### REMARKS

#### Status of the Claims

The Office Action dated August 22, 2002 has been received and its contents carefully considered. Claims 1-20 are pending. Claims 1-20 have been rejected. Claims 1, 7-9 and 14-16 have been amended. Claims 6, 13, 17 and 18 have been cancelled.

FIG. 2

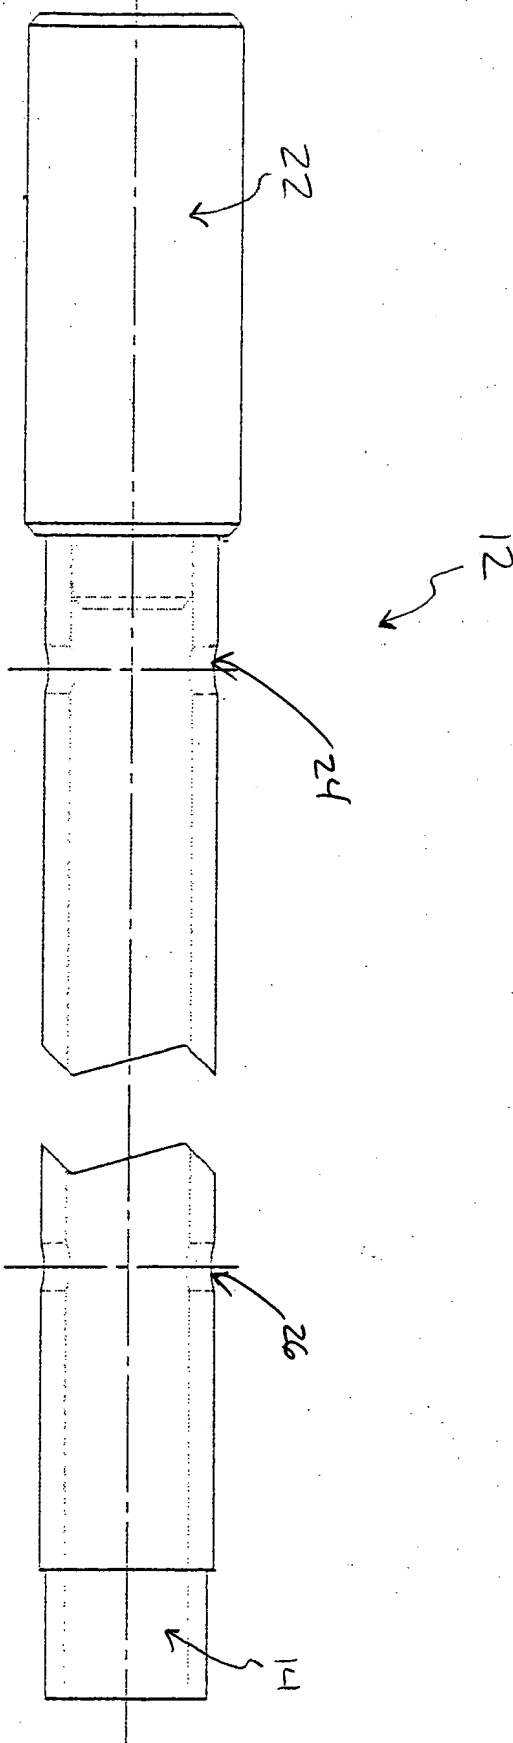
The drawings were rejected under 37 C.F.R. § 1.84(p)(5) because they did not include reference signs as indicated in the previous Office Action. FIG. 2 has been amended to include the receptacles 24 and 26. The restriction 18 and outer member 16 are shown in FIG. 3. It is believed that the drawings are now in compliance.
